GW-023

From: Lowe, Leonard, EMNRD
Sent: Monday, November 01, 2010 5:01 PM
To: 'Warren, Keith'
Cc: VonGonten, Glenn, EMNRD
Subject: GW-023, DCP Midstream Artesia Gas Plant MODIFICATION

Subject: Artesia Gas Plant
Notification of Upcoming Facility Changes
Discharge Permit (GW-23)
Eddy County, New Mexico

ATTACHMENT 2
1,000-GALLON AGI SUMP DETAIL DRAWING

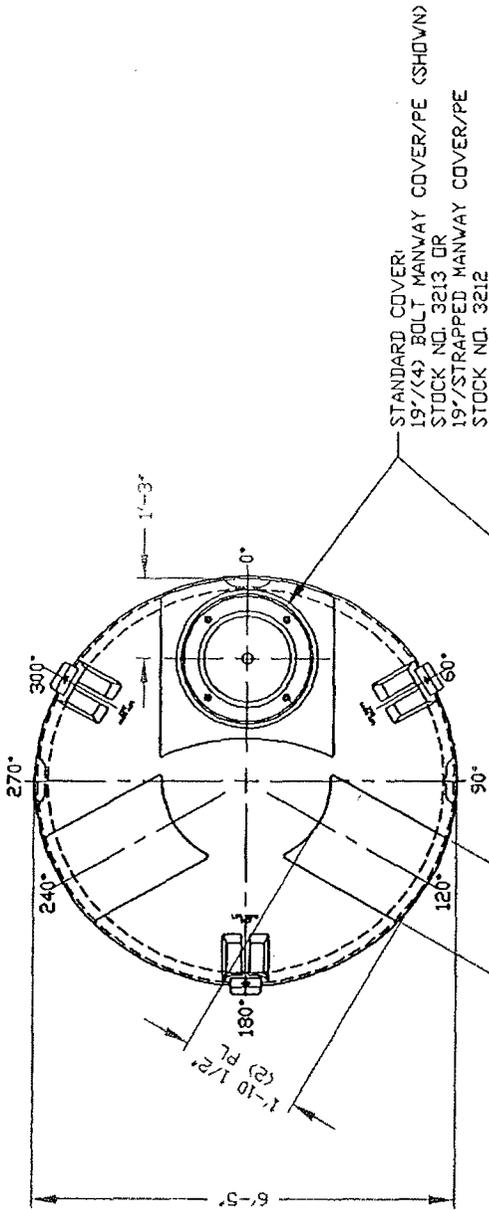
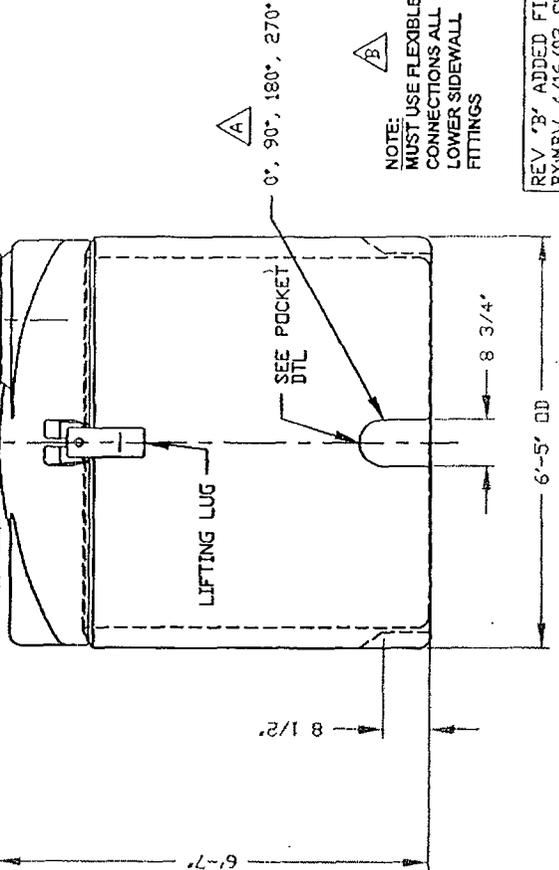
1. It is annotated that "three existing below-grade sumps" are being removed and replaced. *Are these sumps or below grade tanks?*
 - I. AGI sump (Replace with 1000 gallon below-grade sump)

Question: It is noted that the 'AGI sump' is being replaced by a 1000 gallon "Sump", per definition anything greater than 500 gallons is NOT a Sump and is a below-grade tank. Please refer to NMAC for your information. What fluids were noted to be collected in the current "AGI Sump"? What volume capacity is the current "AGI Sump"? Were all historical hydrostatic testing passed for this 'sump'? If not what was done to determine the failed test? What material is made up of the current "Sump"?

ATTACHMENT 3
NEW JACKET WATER AND OILY DRAIN ABOVEGROUND STORAGE TANKS AND
CONTAINMENT SKETCHES AND AVAILABLE SECONDARY CONTAINMENT
VOLUME CALCULATION

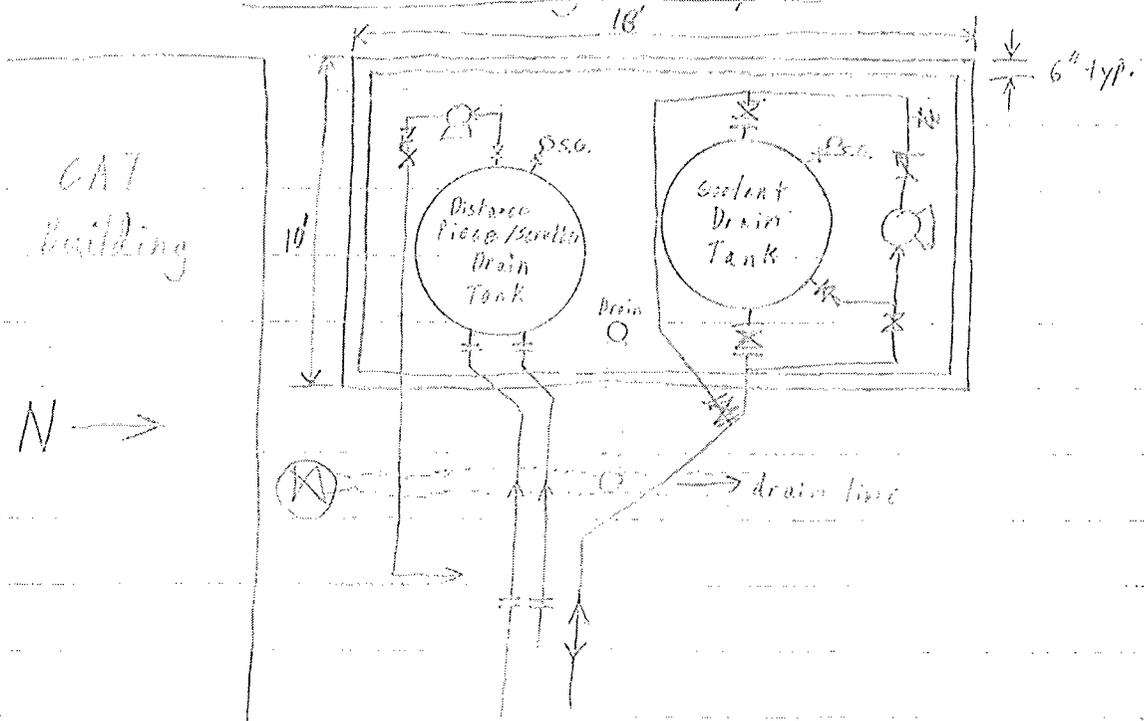
- II. Cat House Jacket Water sump:
Question: What was the maximum volume capacity for this "sump"? What was the major effluent known to 'run' in to this depression? What does DCP consider a 'closure' of this "sump"? Were all historical hydrostatic testing passed for this 'sump'? If not what was done to determine the failed test? What material is made up of the current "Sump"?

- III. Cat House Oily Water Drain Sump: Question:
Question: What was the maximum volume capacity for this "sump"? What was the major effluent known to 'run' in to this depression? What does DCP consider a 'closure' of this "sump"? Were all historical hydrostatic testing passed for this 'sump'? If not what was done to determine the failed test? What material is made up of the current "Sump"?

2. Question for both Cat House "sumps": Will there be a replacement AST or each closed "Sump"? Or just one new AST replacing the two "sumps"?
3. Can you provide a photograph for each of these "sumps"?

**ATTACHEMENT 4
DRAIN LINE REPLACEMENT FIGURE**

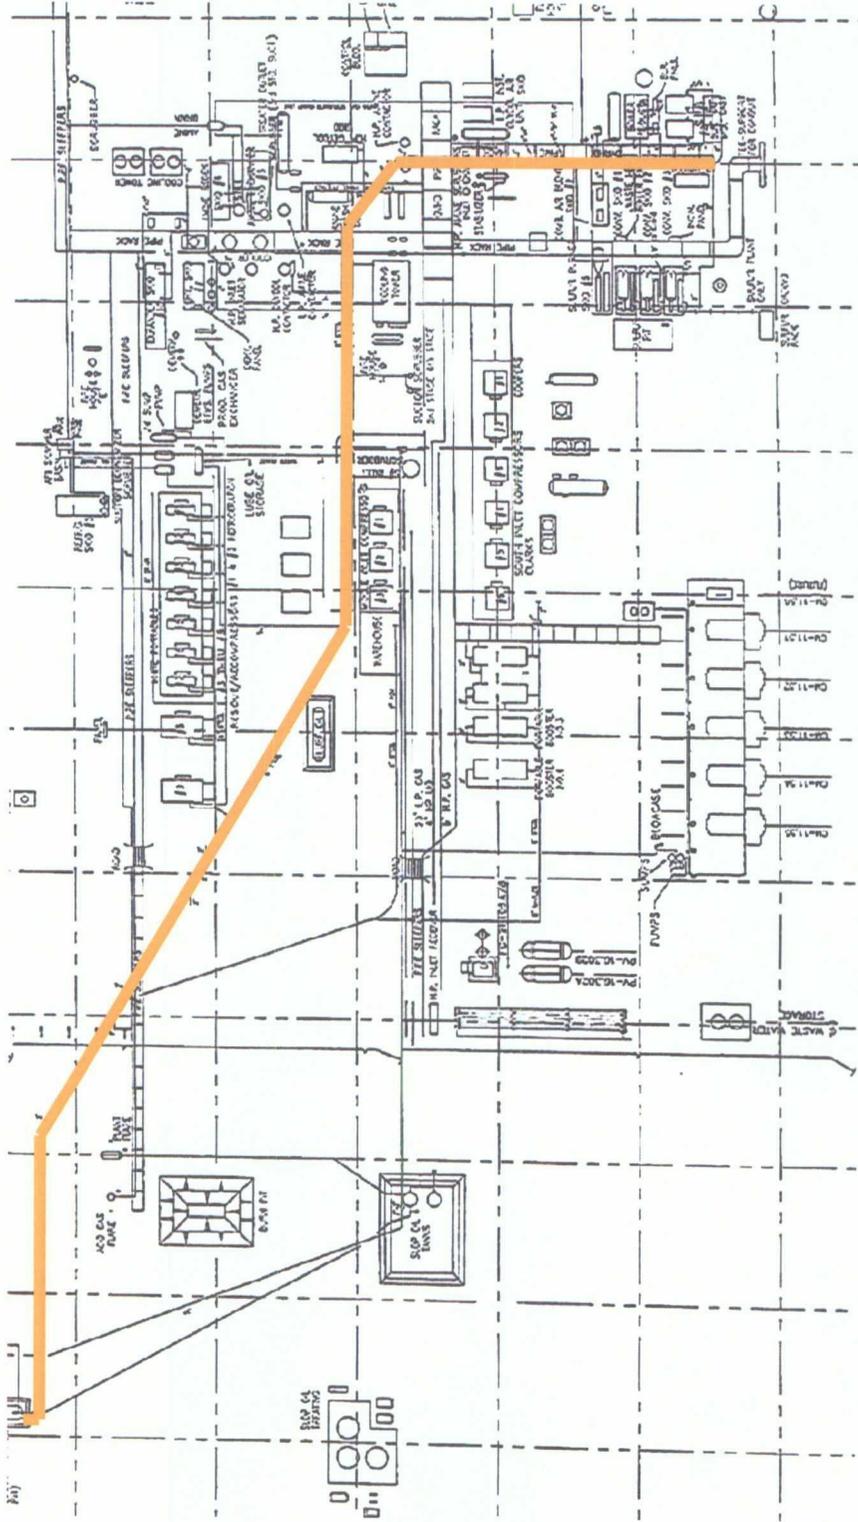
4. Overall, how and where do you intend to dispose of all 'closed' sumps and any other associated waste?
5. Where do you intend to dispose of the 'used 6" pipe'?
